WM. H. ZIMMER POWER STATIONINSTRUCTIONS FOR UPDATING YOUR  
DESIGN ASSESSMENT REPORT

Changes to the MARK II DAR are identified by a vertical line in the right margin of the page. To update your copy of the ZPS-1 DAR, remove and destroy the following pages and figures and insert pages and figures as indicated.

AMENDMENT 15  
MAY 1981

MARK II DESIGN ASSESSMENT REPORT

4TCO LOADS VS. EXISTING  
DESIGN LOC 111 VERT

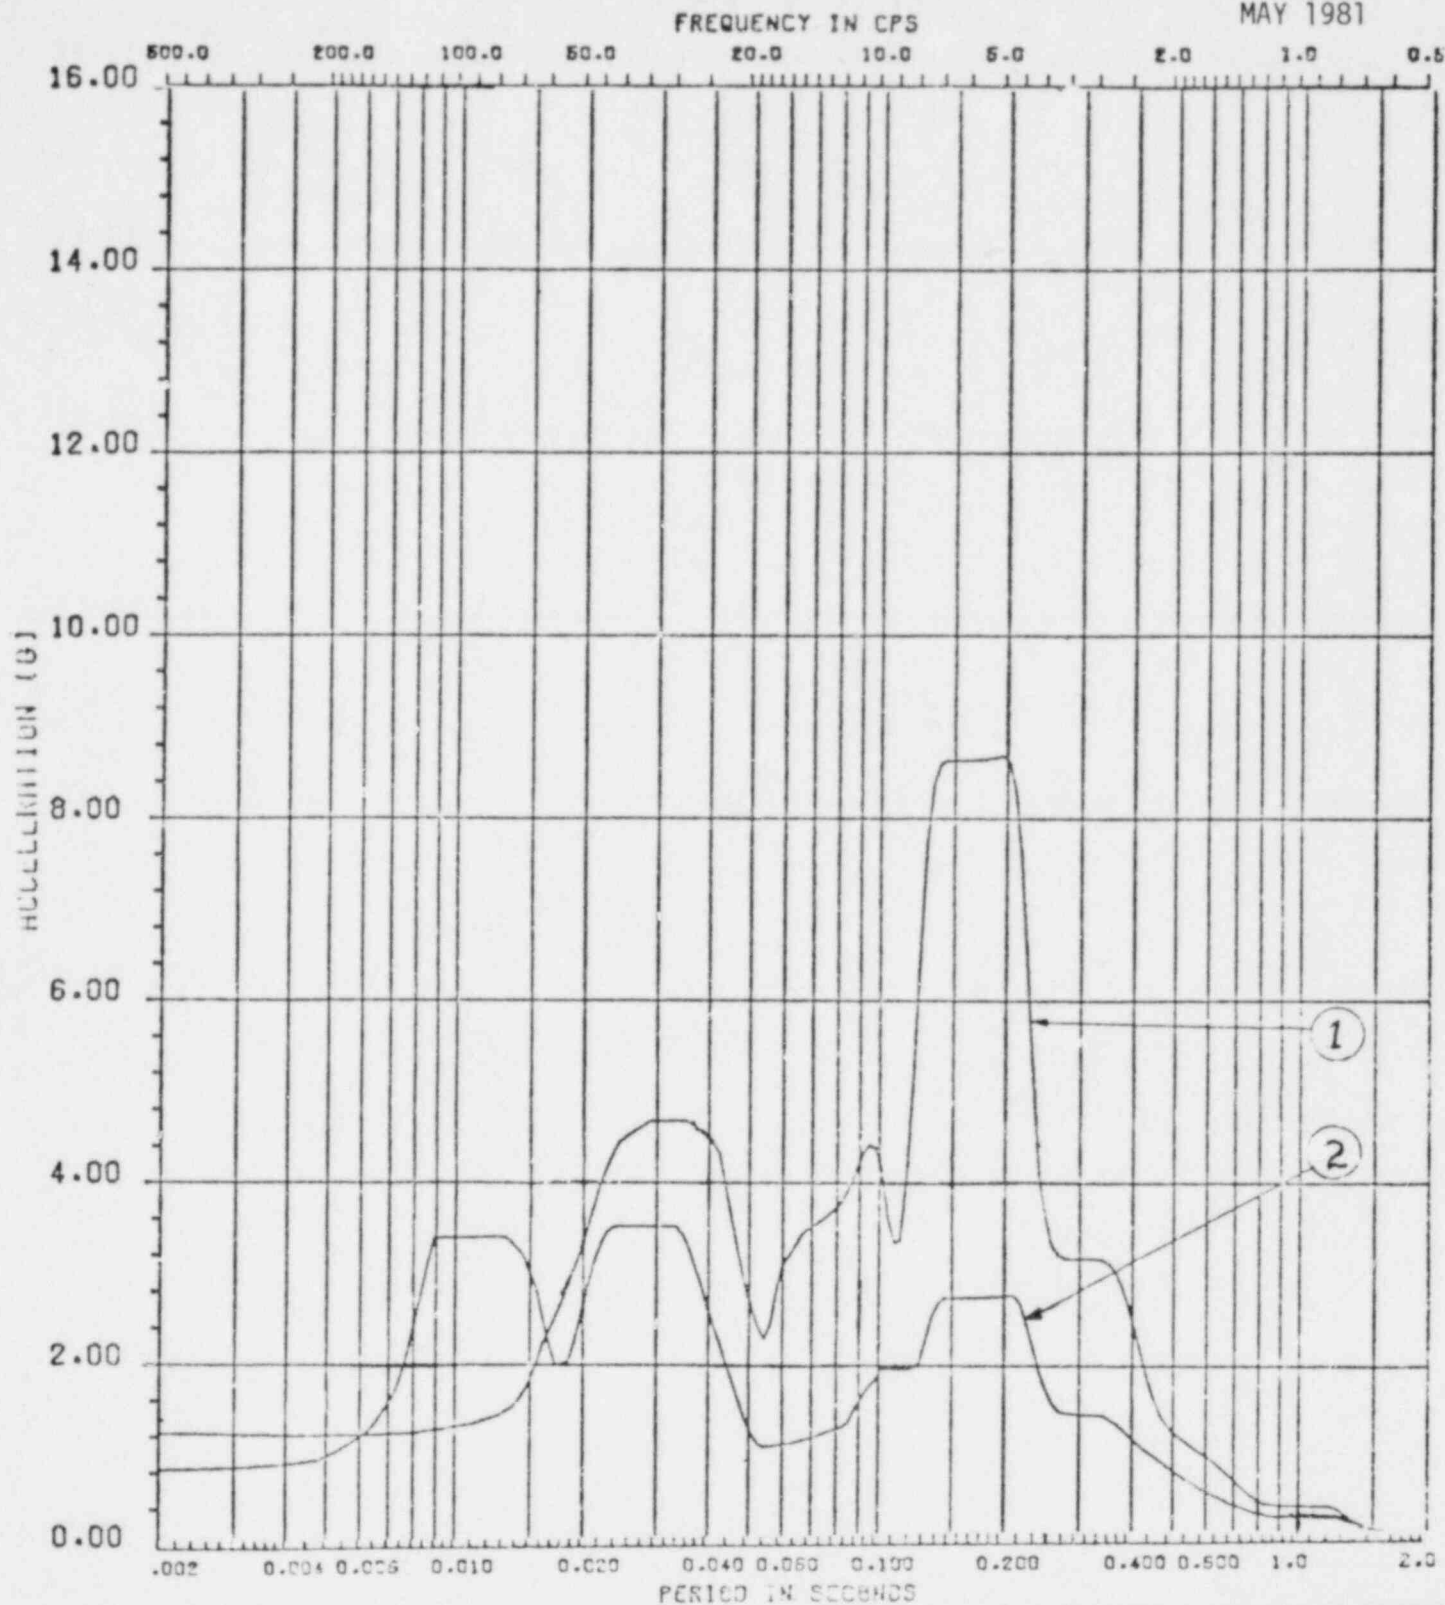
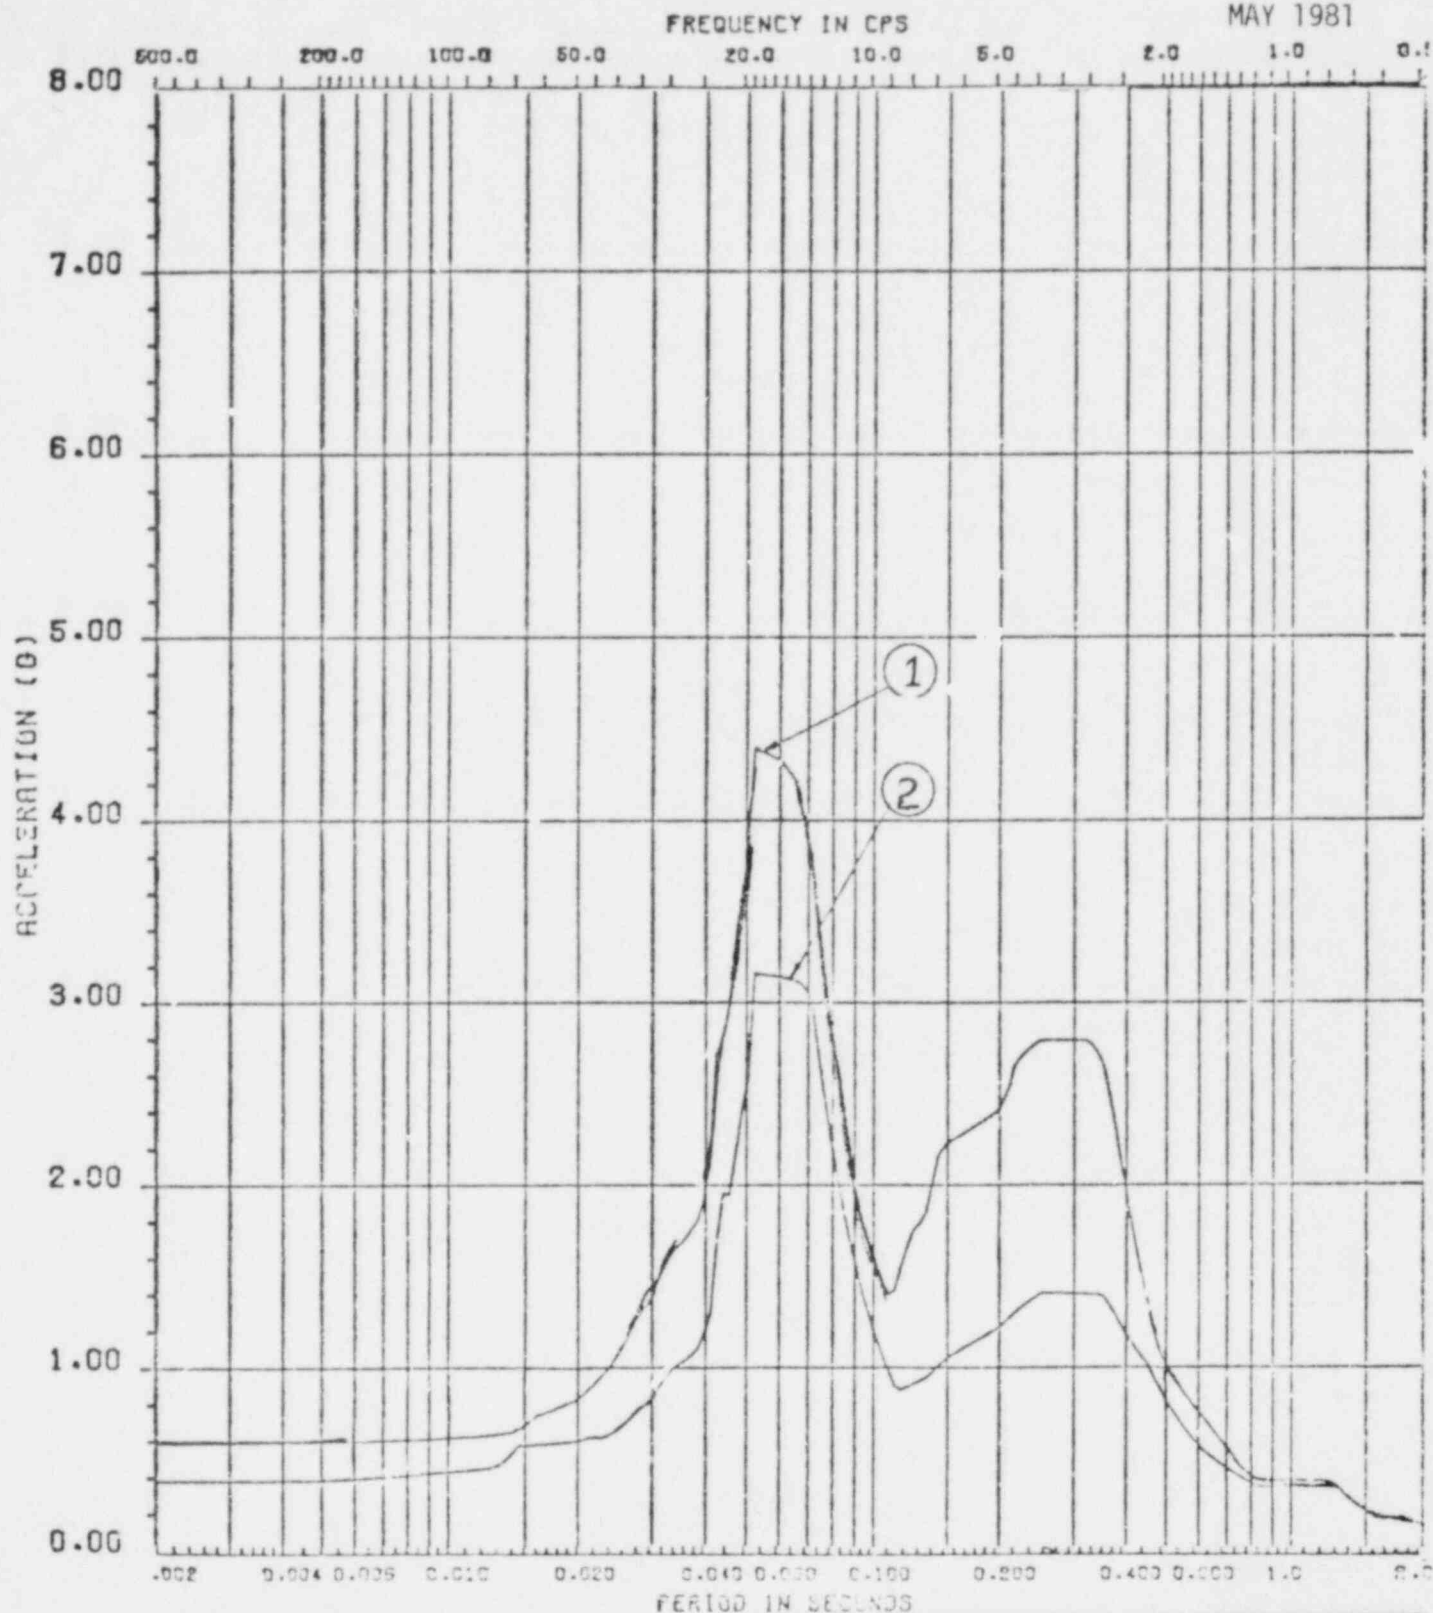
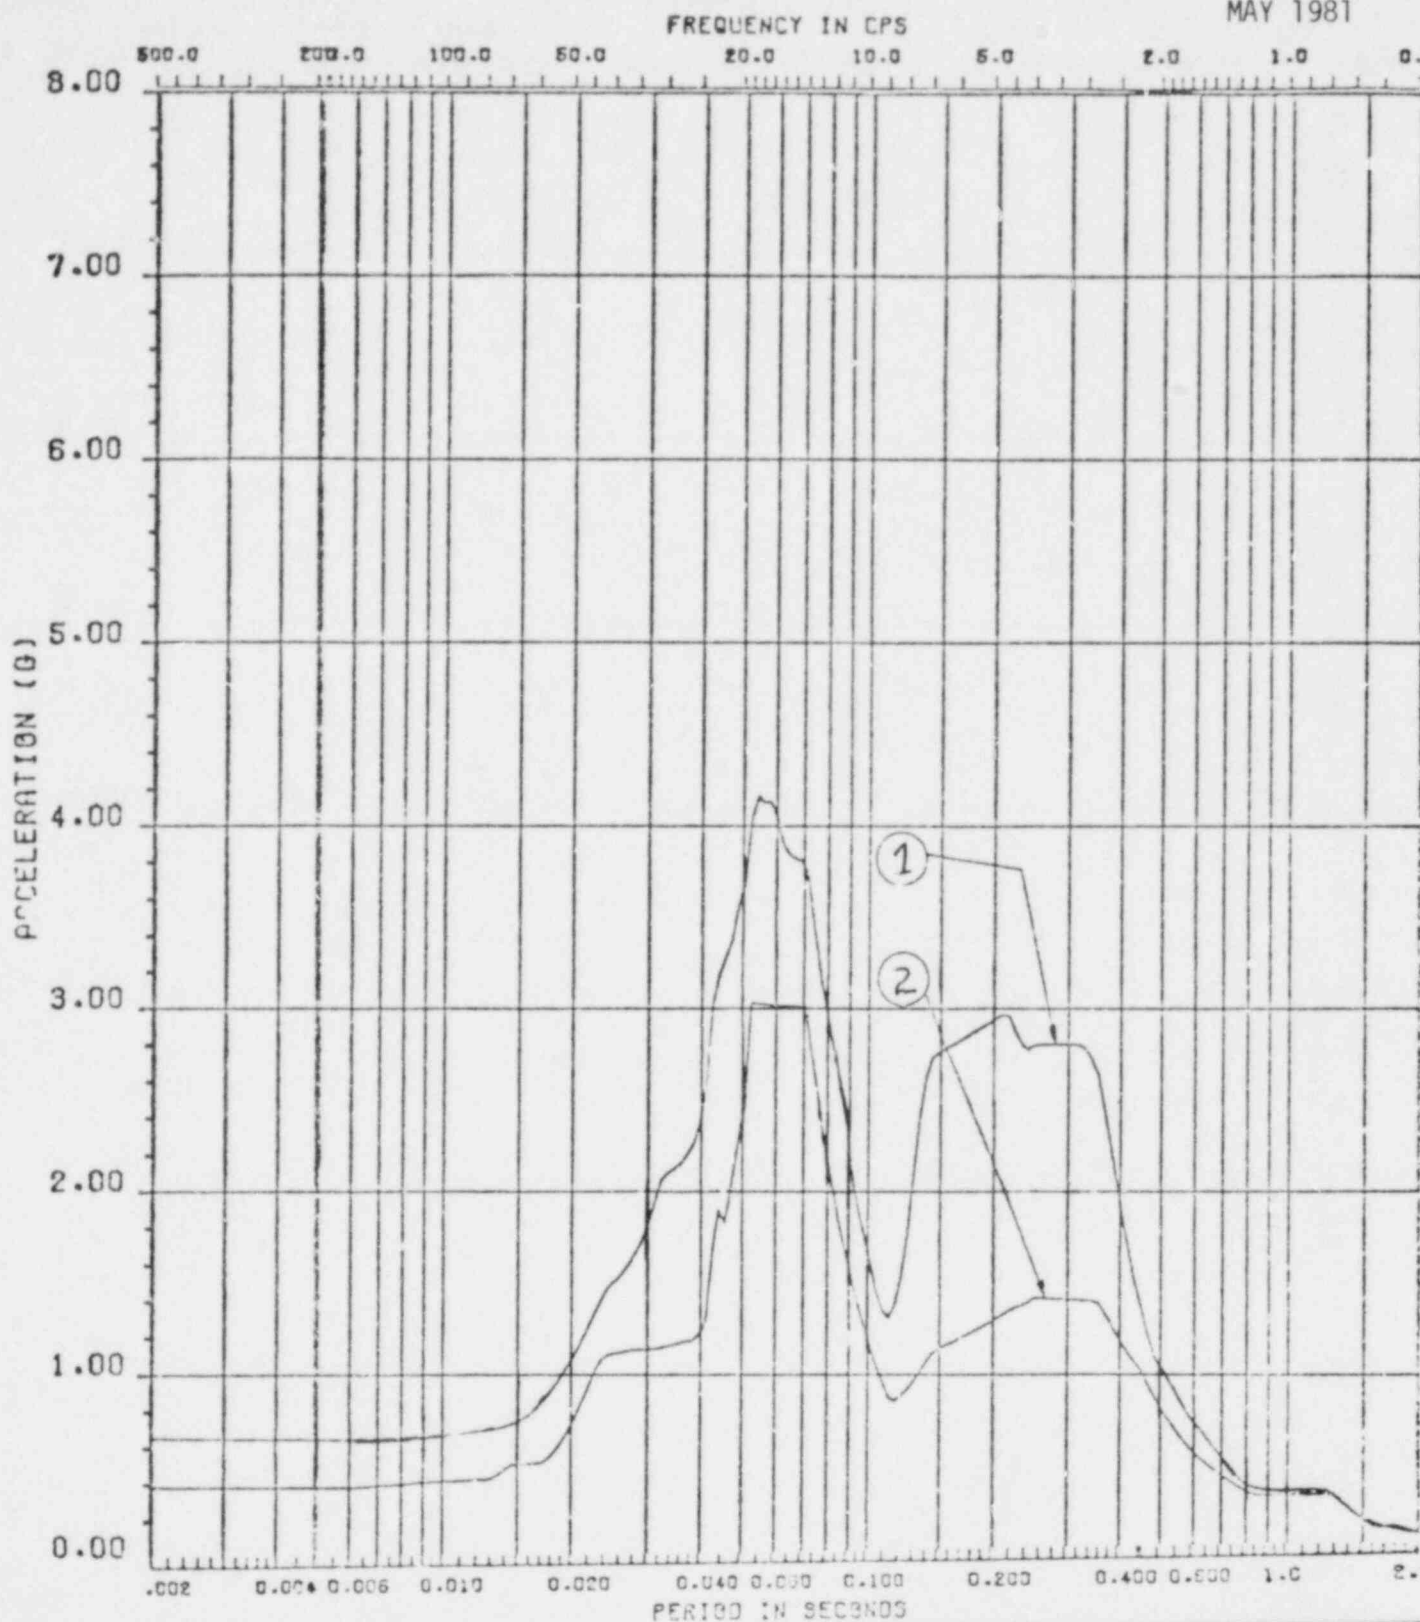
Comparison of typical response spectra envelopes are included here. The two curves represent the Zimmer design basis and a hypothetical design basis utilizing 4TCO data and the SRSS (Square Root of the Sum of the Squares) method of load combinations which has been approved by the NRC for Mark II application.

Curve 1 represents an envelope of the Zimmer Empirical Load (ZEL) Design Basis:

Curve 2 represents an envelope of loads based on 4TCO data combined with seismic and SRV loads:

Each load combination is combined by SRSS. Although a reduction in the SRV (ADS) amplitude multiplier of about 30% (1.1 in place of 1.5) has been approved by NRC, this reduction was not included in this comparison.

These comparisons show that the design basis is very conservative at frequencies below 50 hertz. The occasional exceedences above 50 hertz are not considered significant to the design.
